ULNRC-05448

**DOCKET NUMBER 50-483
CALLAWAY PLANT UNIT 1
UNION ELECTRIC CO.
FACILITY OPERATING LICENSE NPF-30
RESPONSES TO REQUESTS FOR ADDITIONAL INFORMATION
REGARDING GENERIC LETTER 2003-01,
"CONTROL ROOM HABITABILITY"**

**Responses to NRC RAI Questions Regarding Generic Letter 2003-01,
Control Room Habitability**

**Information Required for Alternative Test Methods to determine in-
leakage of air in the Control Room Envelope.
Revision 2**

Figure 1 Simplified schematic of flows into the Control room Envelope

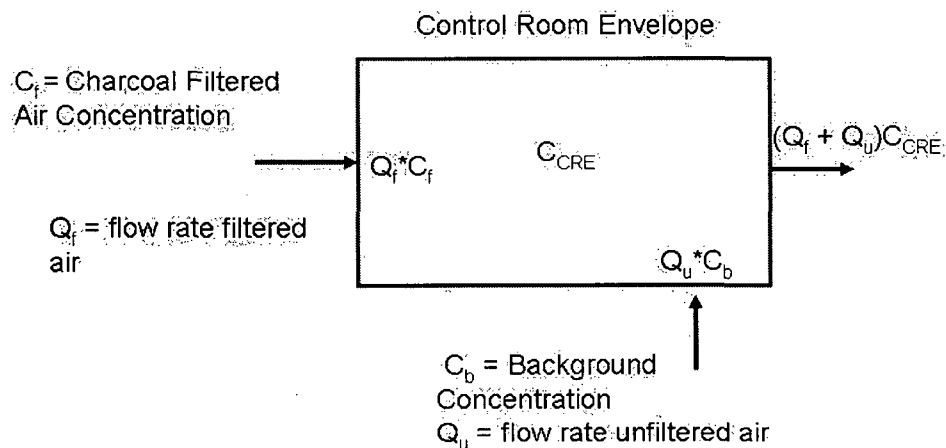
In the Brookhaven document, section 1. Summary of the test method, Figure 1 Simplified schematic of flows into the Control room Envelope; a parameter C_b is identified as Background Concentration. In section 3. Parameter specifications; it refers to Figure 1 and the unfiltered PFT concentration (C_u) and shows an equation using C_u. Are “C_b” and “C_u” the same thing?

Yes, the text has been clarified by changing C_b to C_u. in Figure 1 and the adjacent text in the revised Brookhaven National Laboratory report provided as Attachment 2.
